PRODUCT/PROCESS CHANGE NOTICE (PCN)

PCN #: Q1703-02 DATE: 2-May-2017 Product Affected: F1423NBGI(8) Date Effective: 2-Aug-2017	MEANS OF DISTINGUISHING CHANGED DEVICES: <input type="checkbox"/> Product Mark <input type="checkbox"/> Back Mark <input type="checkbox"/> Date Code <input checked="" type="checkbox"/> Other Materials used is traceable through Assembly Lot#
--	---

PCN Type: Change of Die Size

Detail Of Change:

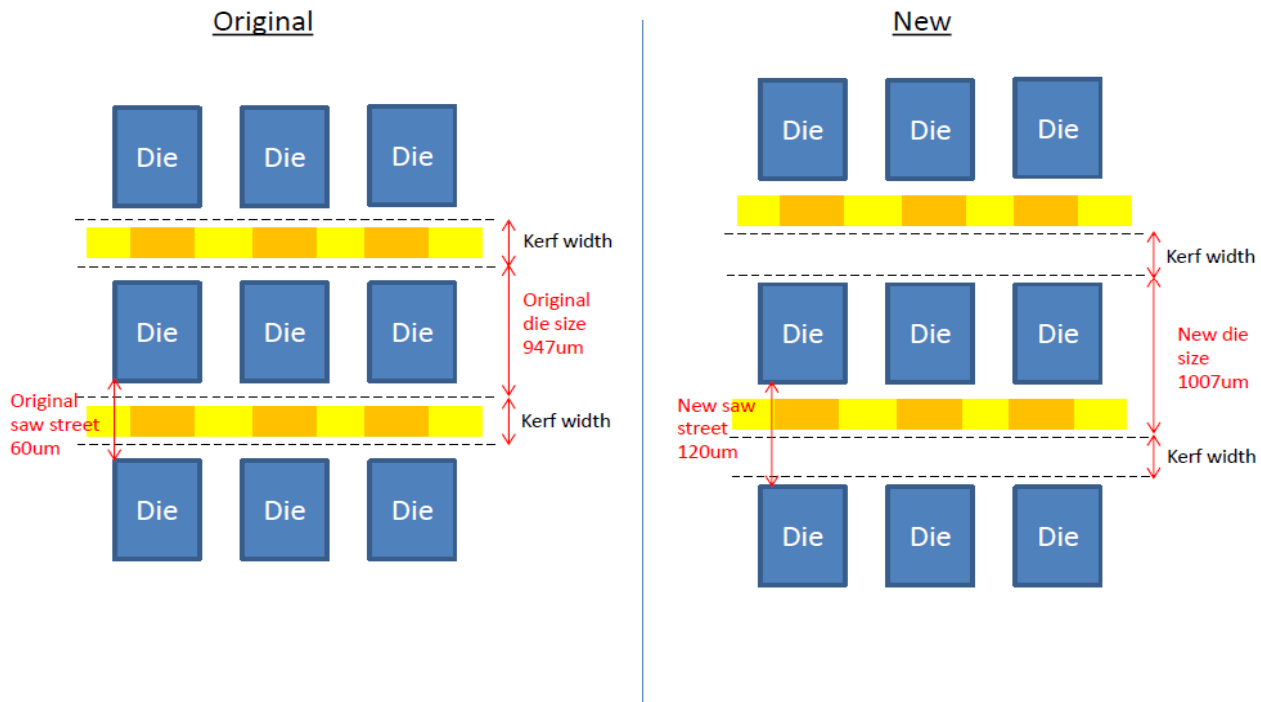
This notification is to advise our customers that select IDT parts are being converted to a 530um x 1007um die size from a 530um x 947um die size as a result of the increased to the saw street width dimension. This change is being made to improve manufacturing capability. Refer to the below illustration.

There is no change to the product design or process technology.
There is also no change to the package, backend manufacturing process or the the data sheet and ordering part number.
